Safety Evaluation Report

Renewal of the Facility Operating License for the
Nuclear Science Center Reactor

Docket No. 50-128

Texas Engineering Experiment Station/Texas A&M University System

Figure 1: Organization Chart for Reactor Administration

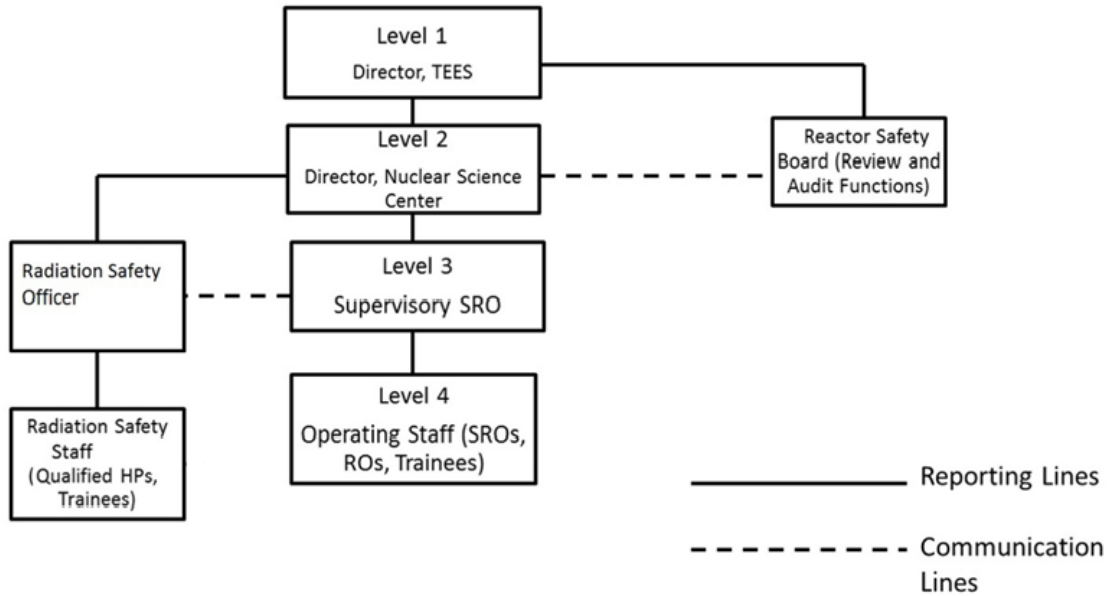
TS 6.1 helps ensure that NSC organizational responsibilities are delineated. The NRC staff finds that the organization described in TS 6.1 is consistent with the guidance in NUREG-1537 and ANSI/ANS-15.1-2007. On the basis of the information provided above, the NRC staff concludes that TS 6.1 is acceptable.

TS 6.1.1 helps ensure that the NSC organization structure is delineated. The NRC staff reviewed TS 6.1.1 and finds that the NSC organizational structure described in TS 6.1.1, and shown in Figure 1, is consistent with the guidance in NUREG-1537 and ANSI/ANS-15.1-2007. On the basis of its review of the information provided above, the NRC staff concludes that TS 6.1.1 is acceptable.
